**COPIES OF CORRESPONDENCE AND
PREVIOUSLY-ISSUED FAA AERONAUTICAL
STUDIES
(DETERMINATIONS OF NO HAZARD)
IESI TRAVIS COUNTY LANDFILL**

SUBJECT: IESI Travis County Landfill (revised)
9600 FM 812
Austin, TX 78719-9734
Case No. SP-2018-XXXX

**Subject: IESI Travis County Landfill
Permit application
Lateral expansion**

Additional information for ASN 2007-ASW-9270-OE

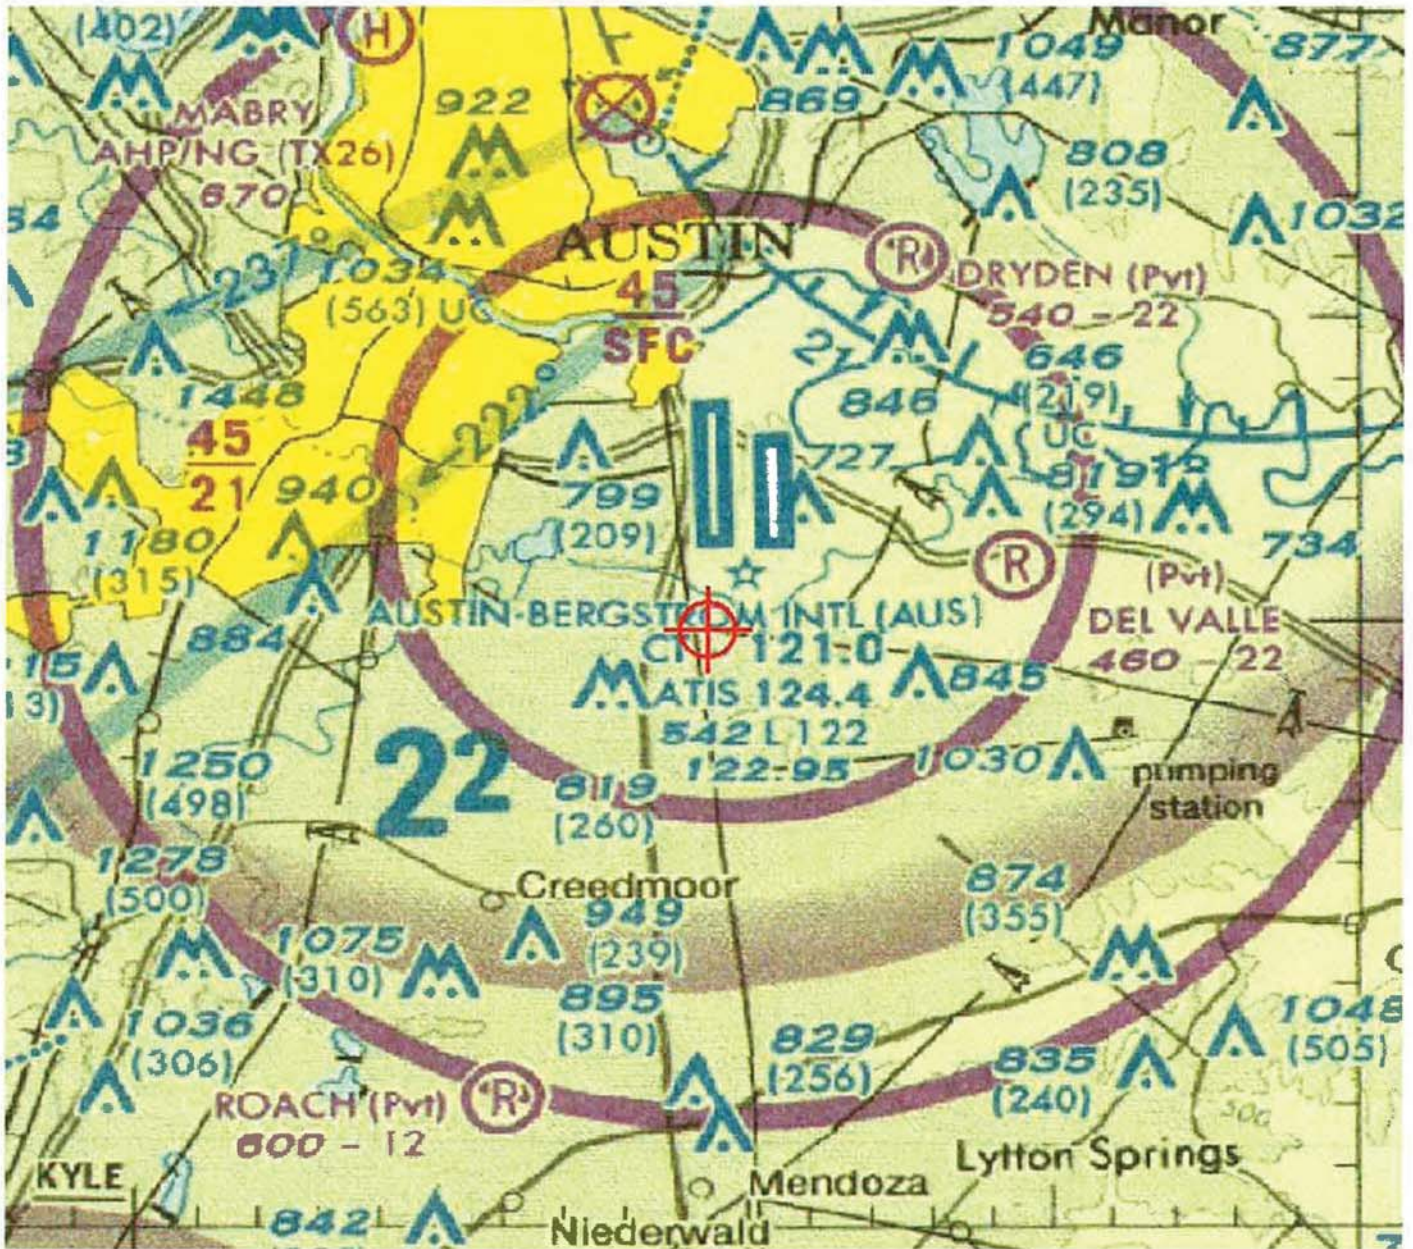
The landfill itself does not exceed any obstruction standards contained in 14 CFR Part 77. Standards are exceeded only when the 15-foot equipment is added into the equation.

This determination includes the maximum height of the landfill, plus the use of 15-foot equipment. When the equipment is working at the maximum height of the landfill, all equipment shall be obstruction flagged during daytime hours. All equipment shall be removed from the highest point of the landfill at night.

Additional information for ASN 2007-ASW-9271-OE

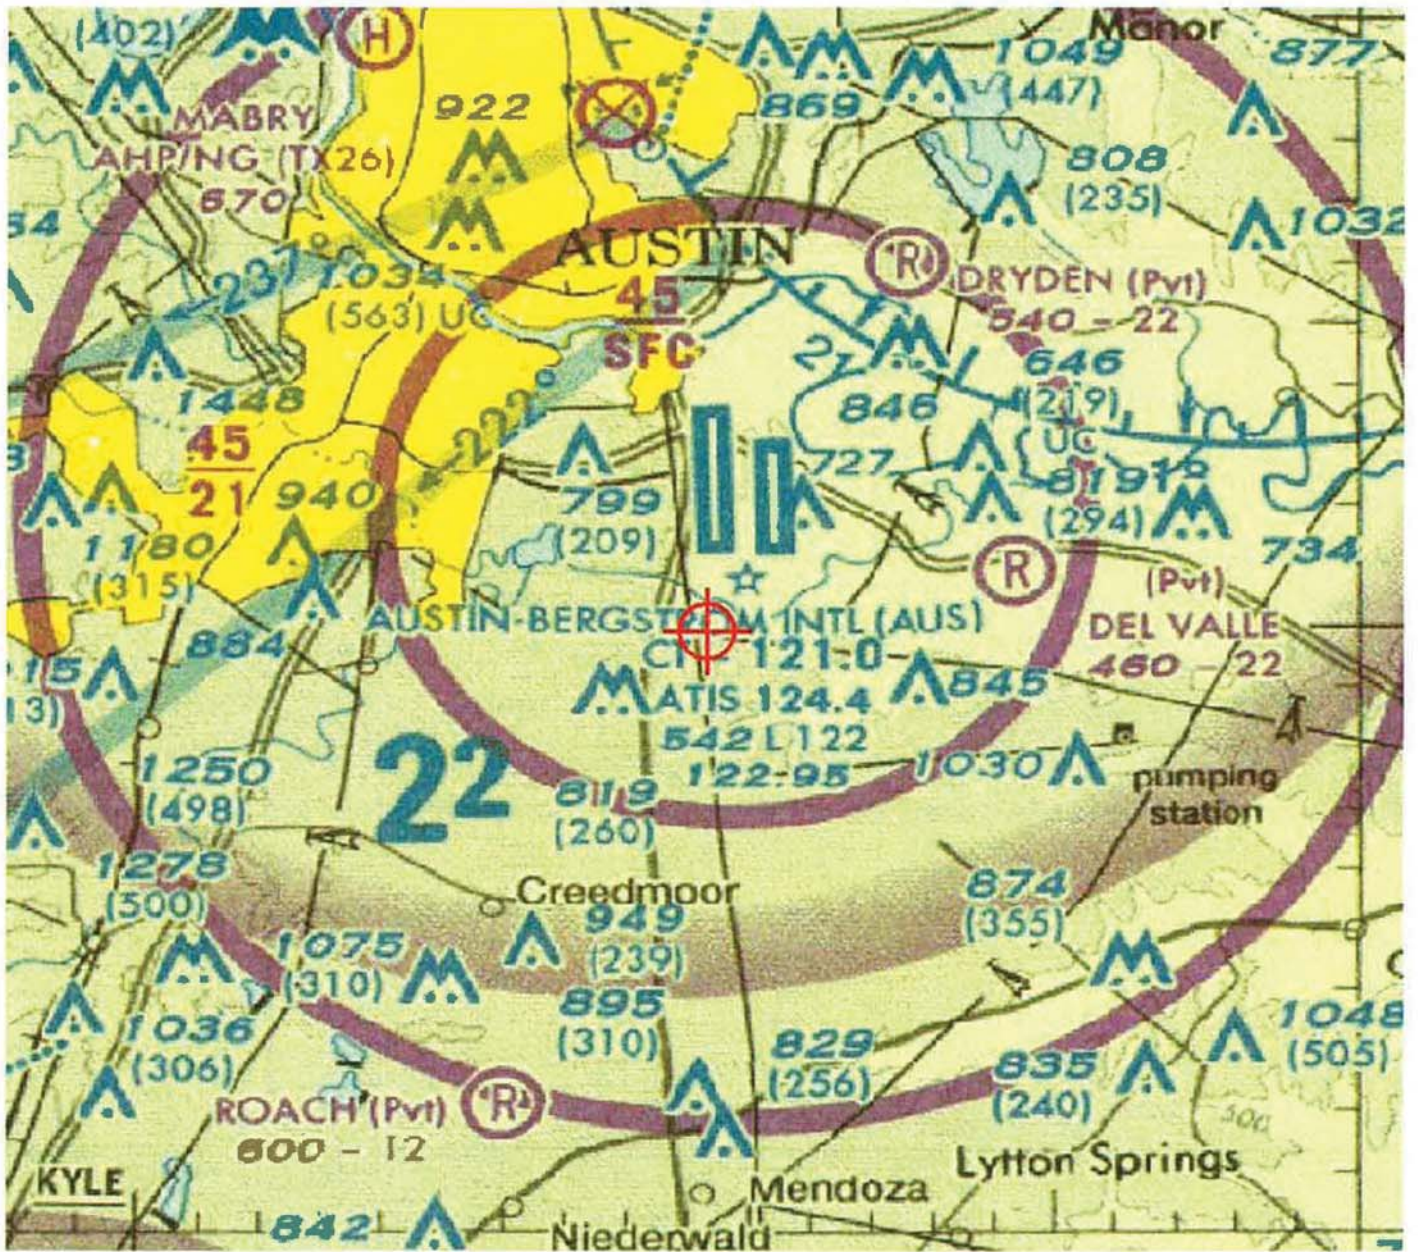
The landfill itself does not exceed any obstruction standards contained in 14 CFR Part 77. Standards are exceeded only when the 15-foot equipment is added into the equation.

This determination includes the maximum height of the landfill, plus the use of 15-foot equipment. When the equipment is working at the maximum height of the landfill, all equipment shall be obstruction flagged during daytime hours. All equipment shall be removed from the highest point of the landfill at night.

Additional information for ASN 2007-ASW-9272-OE

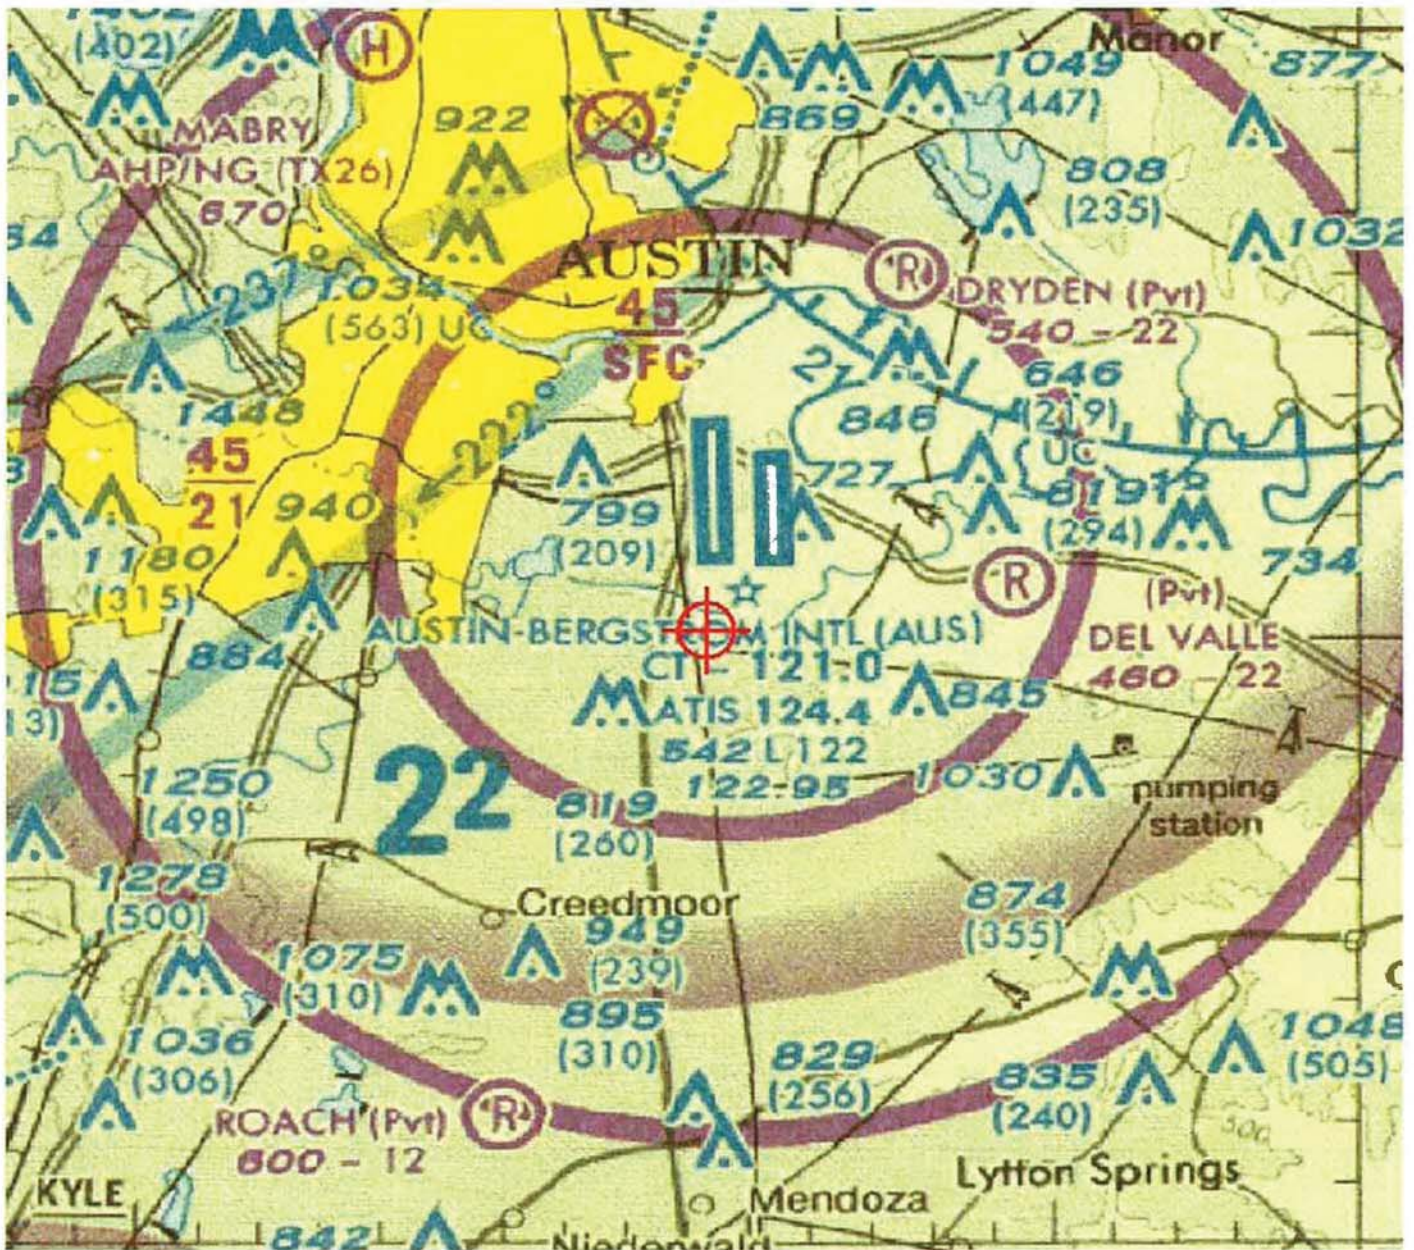
The landfill itself does not exceed any obstruction standards contained in 14 CFR Part 77. Standards are exceeded only when the 15-foot equipment is added into the equation.

This determination includes the maximum height of the landfill, plus the use of 15-foot equipment. When the equipment is working at the maximum height of the landfill, all equipment shall be obstruction flagged during daytime hours. All equipment shall be removed from the highest point of the landfill at night.

Additional information for ASN 2007-ASW-9273-OE

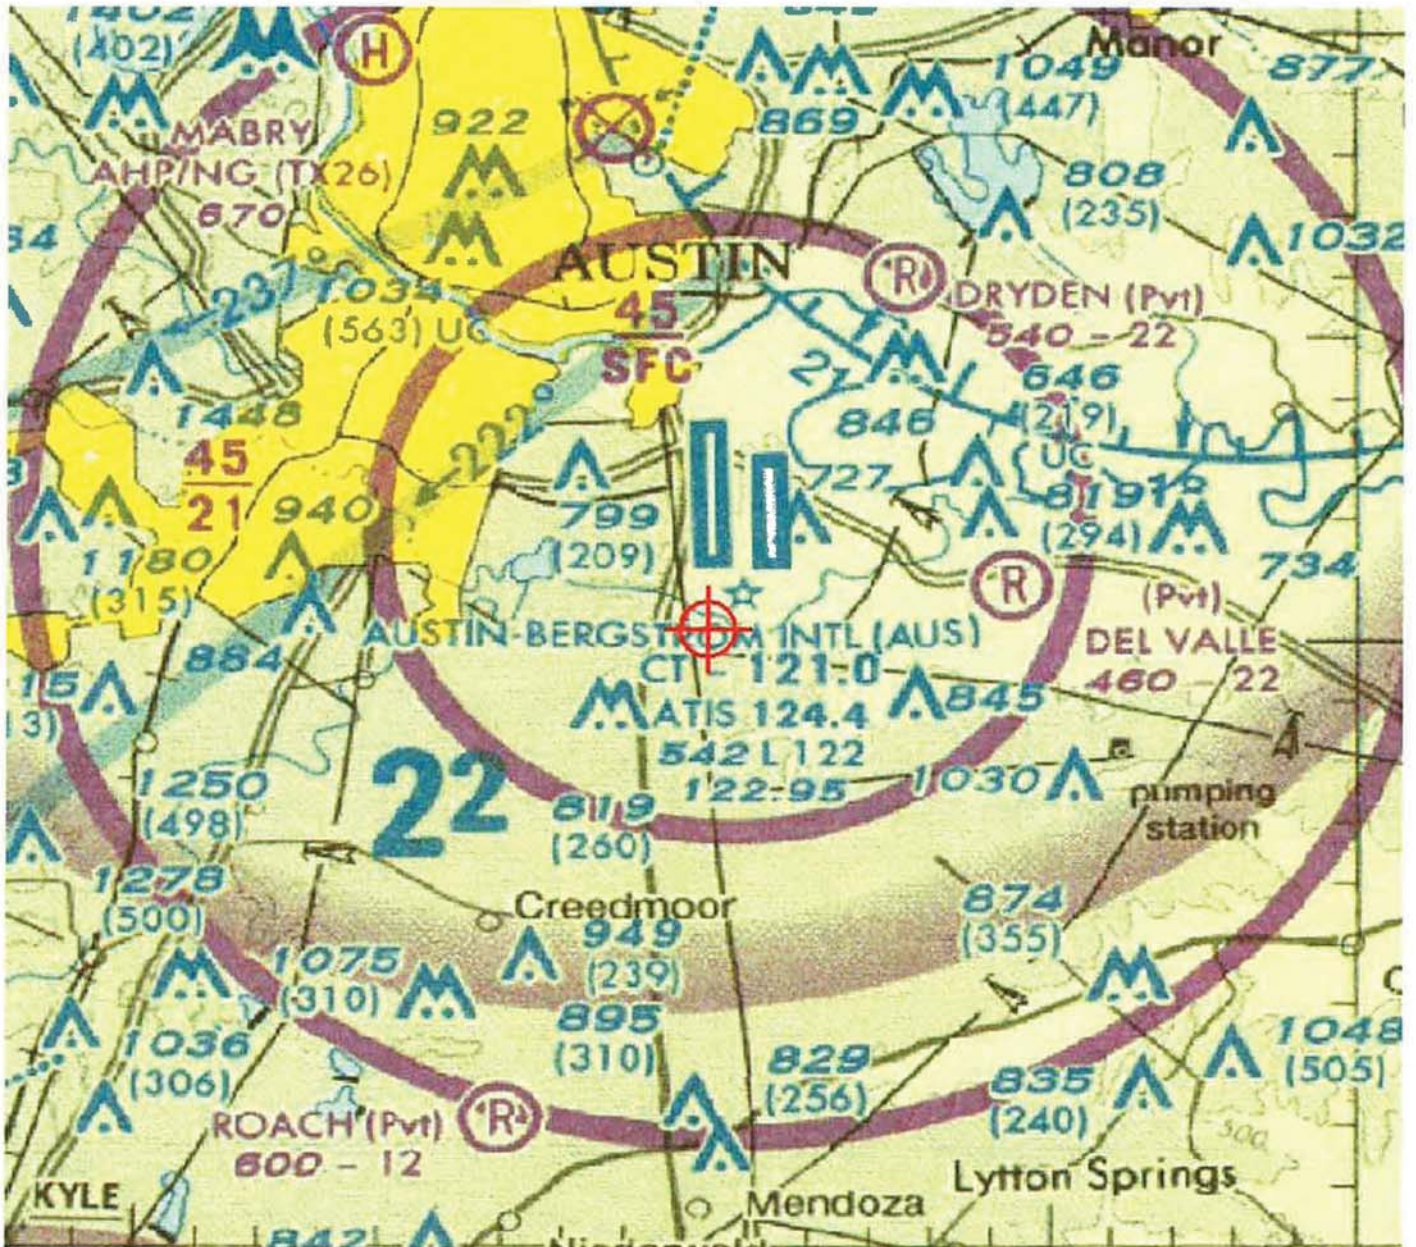
The landfill itself does not exceed any obstruction standards contained in 14 CFR Part 77. Standards are exceeded only when the 15-foot equipment is added into the equation.

This determination includes the maximum height of the landfill, plus the use of 15-foot equipment. When the equipment is working at the maximum height of the landfill, all equipment shall be obstruction flagged during daytime hours. All equipment shall be removed from the highest point of the landfill at night.

Additional information for ASN 2007-ASW-9274-OE

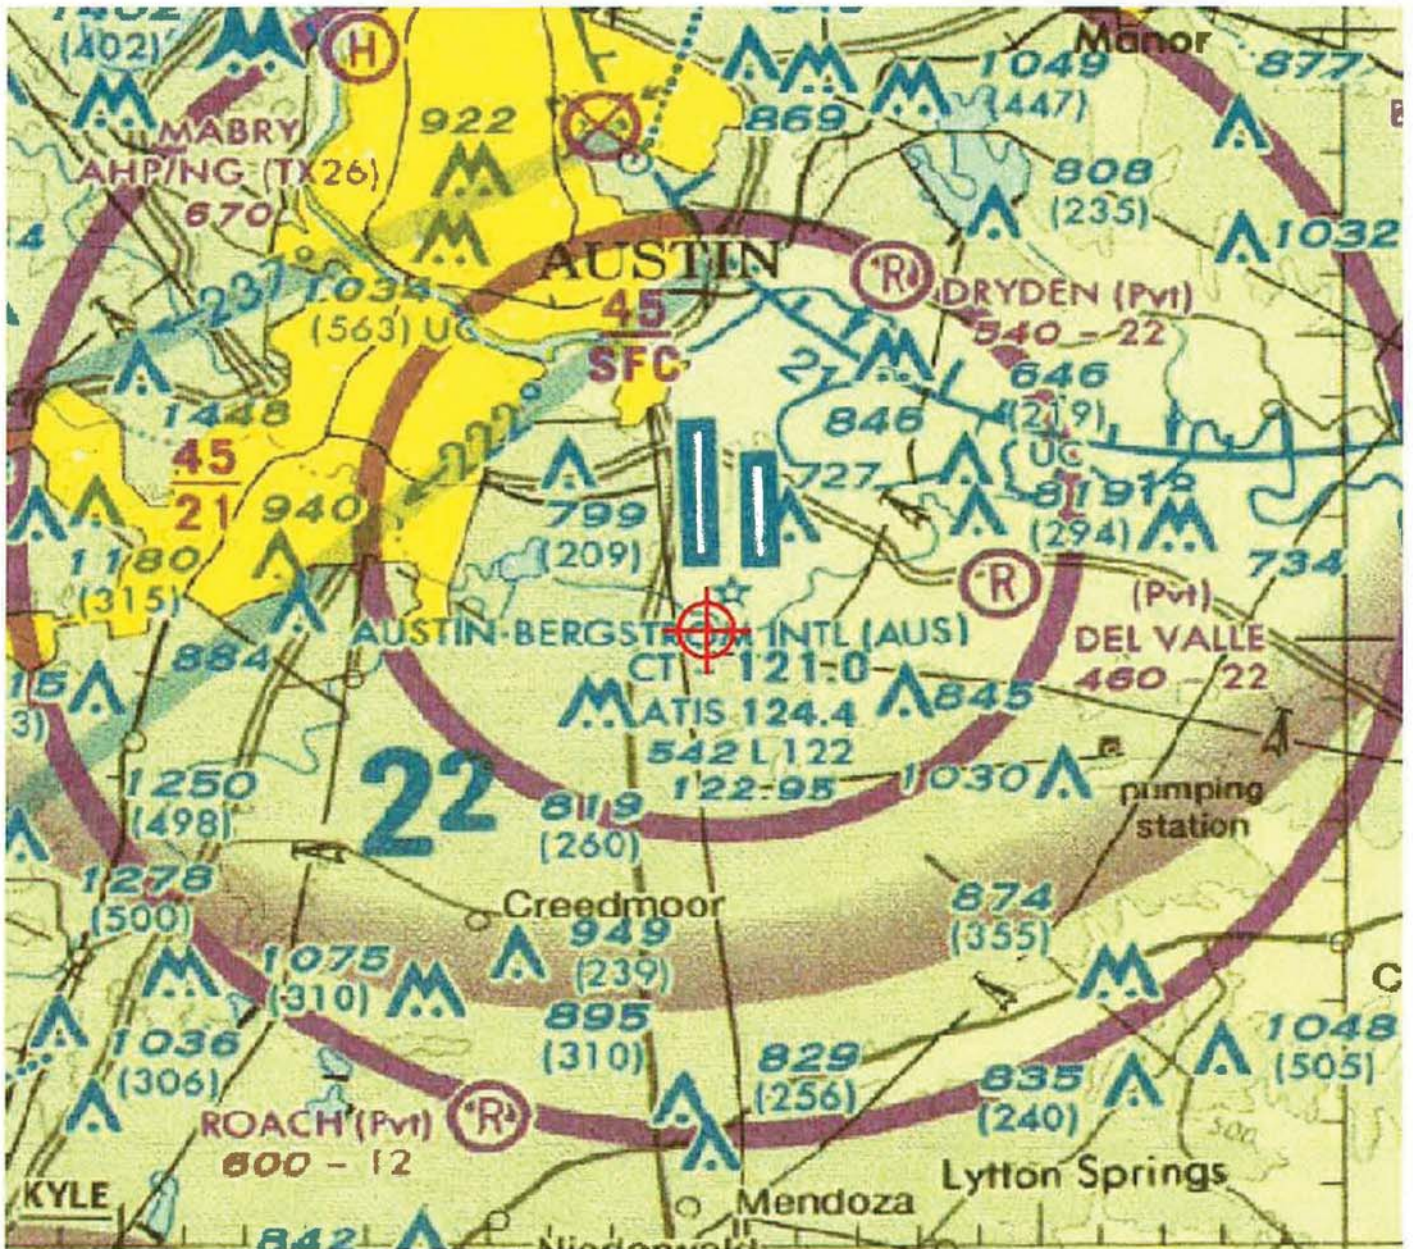
The landfill itself does not exceed any obstruction standards contained in 14 CFR Part 77. Standards are exceeded only when the 15-foot equipment is added into the equation.

This determination includes the maximum height of the landfill, plus the use of 15-foot equipment. When the equipment is working at the maximum height of the landfill, all equipment shall be obstruction flagged during daytime hours. All equipment shall be removed from the highest point of the landfill at night.

Additional information for ASN 2007-ASW-9275-OE

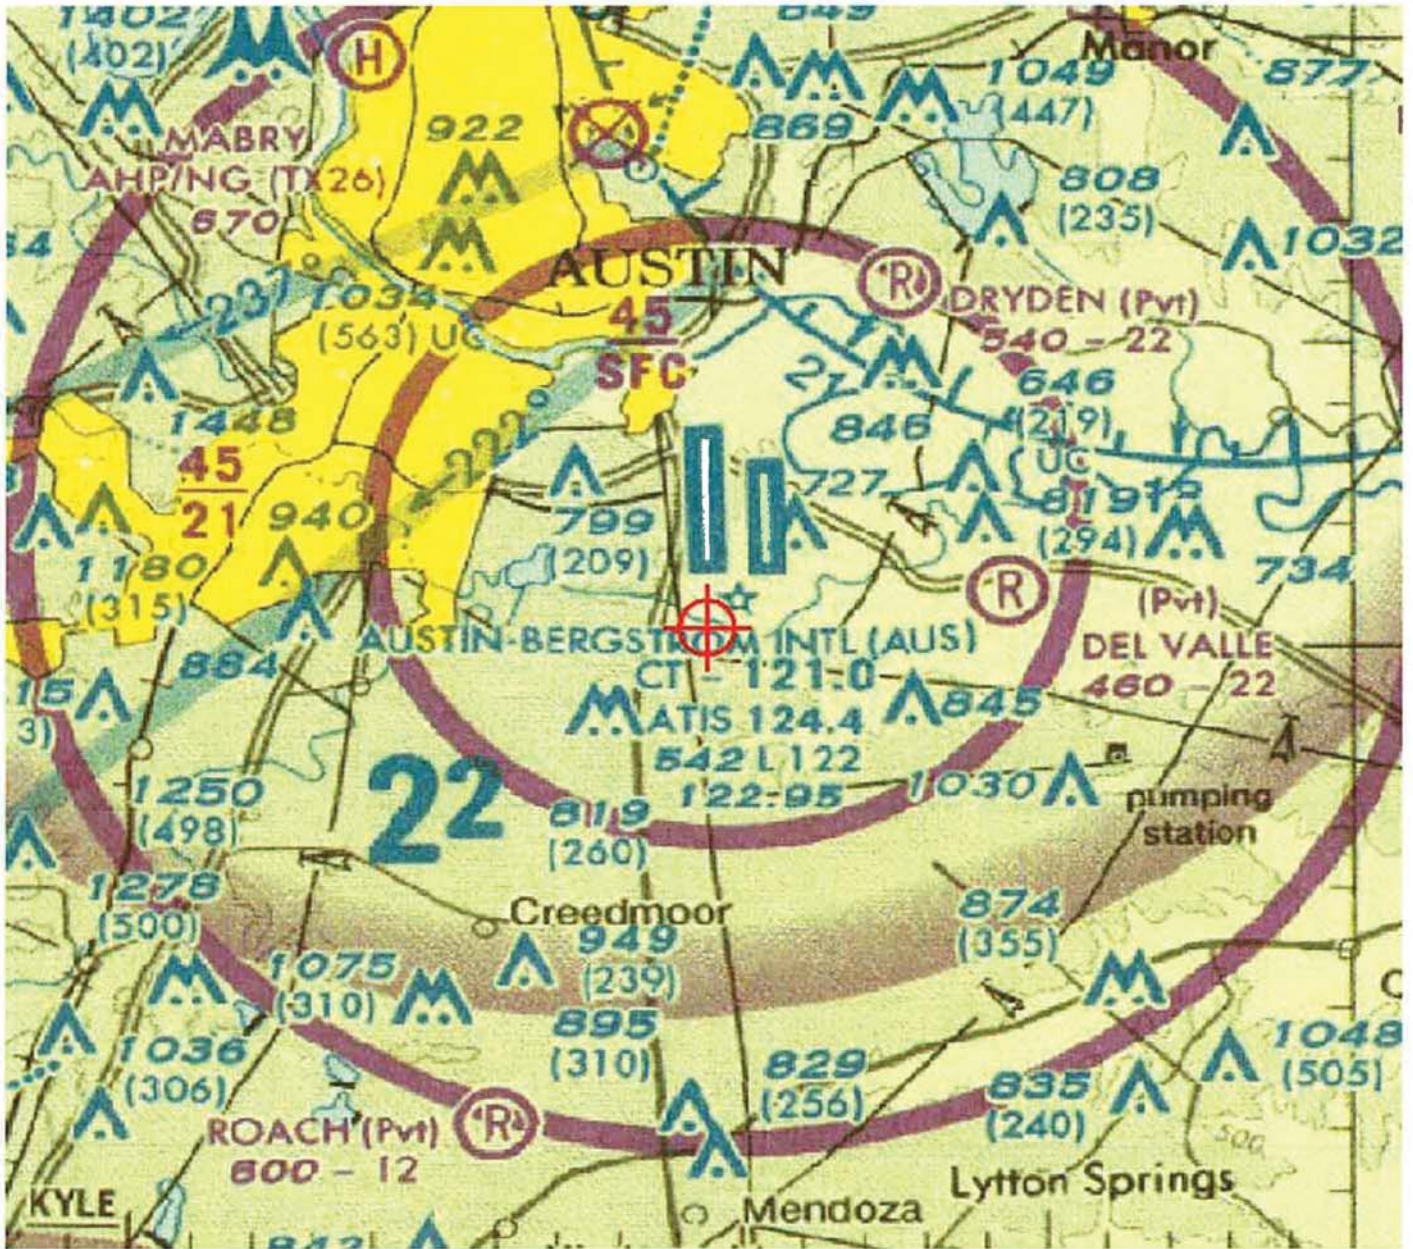
The landfill itself does not exceed any obstruction standards contained in 14 CFR Part 77. Standards are exceeded only when the 15-foot equipment is added into the equation.

This determination includes the maximum height of the landfill, plus the use of 15-foot equipment. When the equipment is working at the maximum height of the landfill, all equipment shall be obstruction flagged during daytime hours. All equipment shall be removed from the highest point of the landfill at night.
